AMENDMENTS TO THE DRAWINGS

Sheets with corrected Figures 6, 7, and 8 are submitted herewith.

FIG. 6

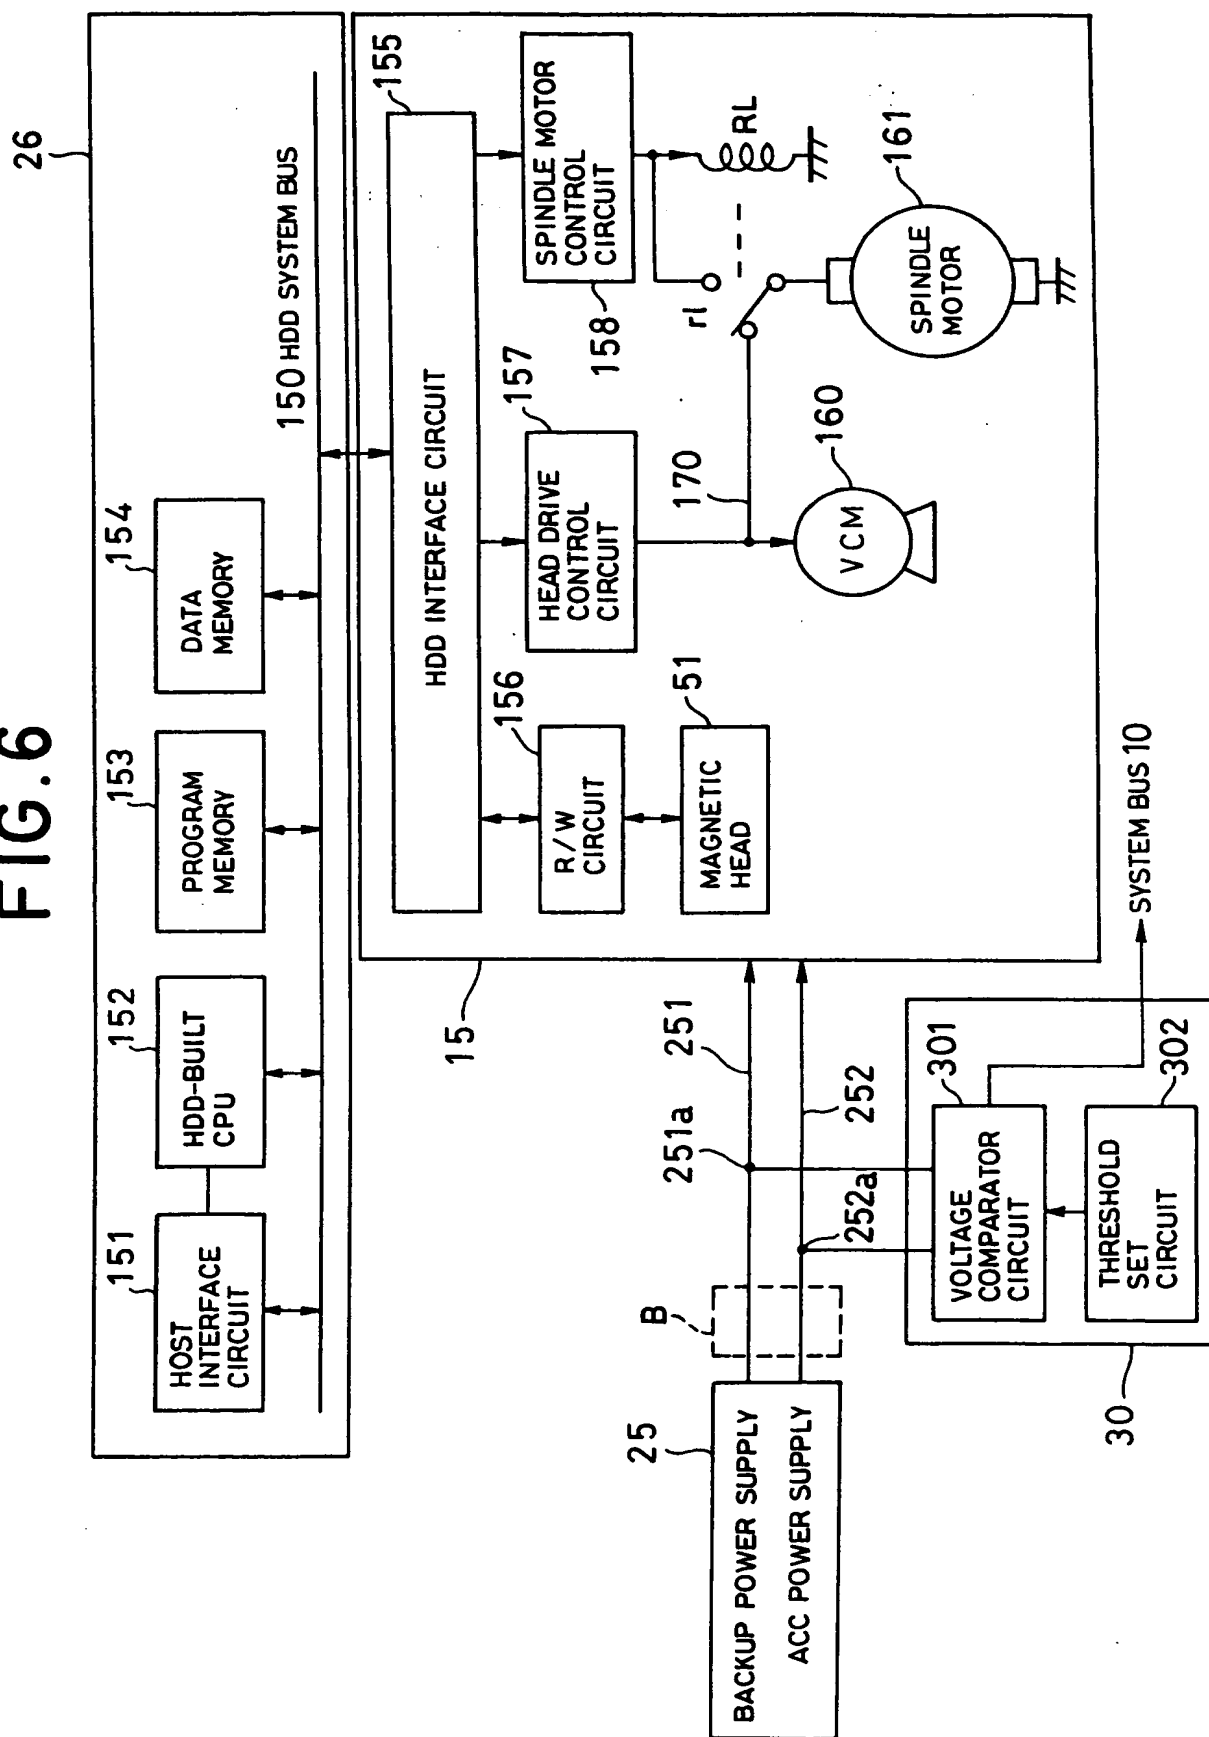
Figure 6 is corrected to change reference character 252b to 252a so as to agree with the specification at page 10, line 3 and to add reference numeral 160 to the VCM, in accordance with the specification at page 9, line 20.

FIG. 7A

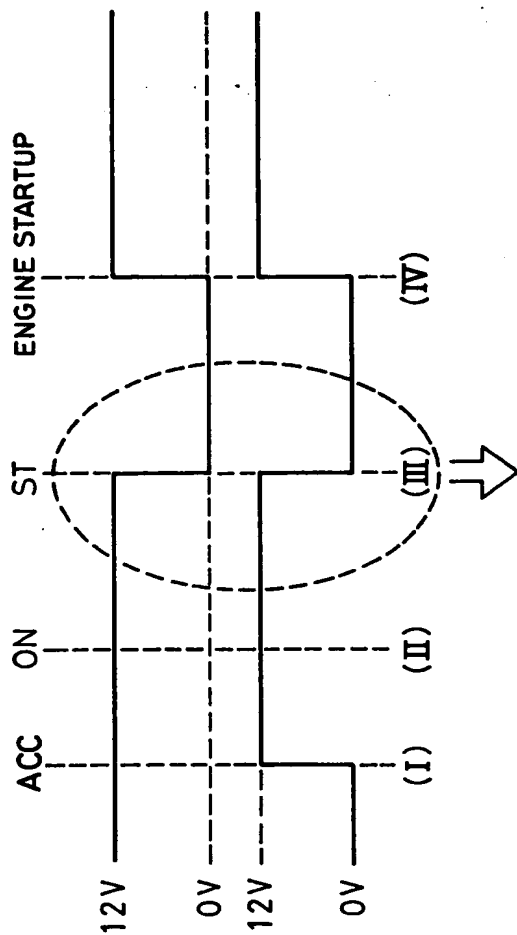
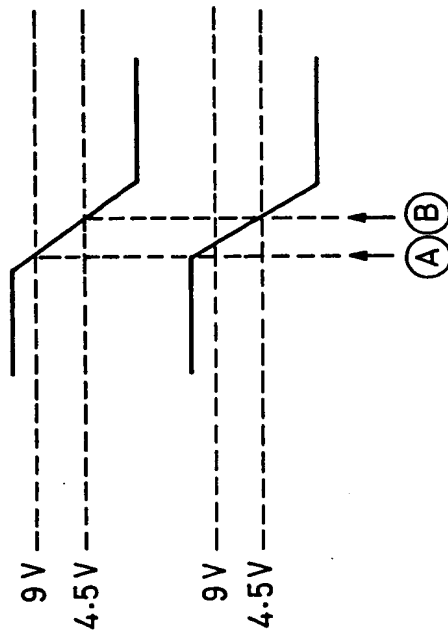
Figure 7 is corrected to correct legend "Acc" to "ACC" so as to agree with the specification and with Figure 4.

FIG. 8A

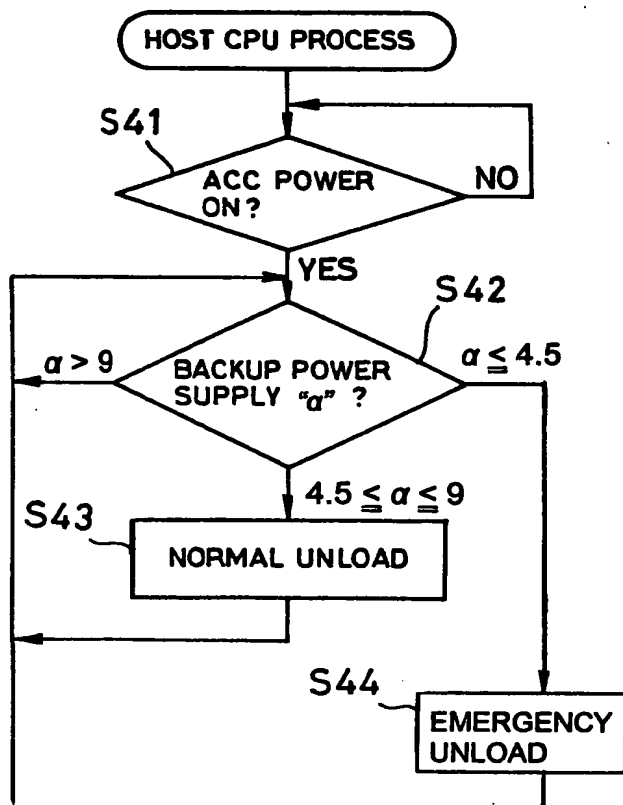
Figure 8 is corrected to correct the outputs of block S 42 and to add block S44 so as to agree with the specification at page 11, line 19 to page 12, line 3.
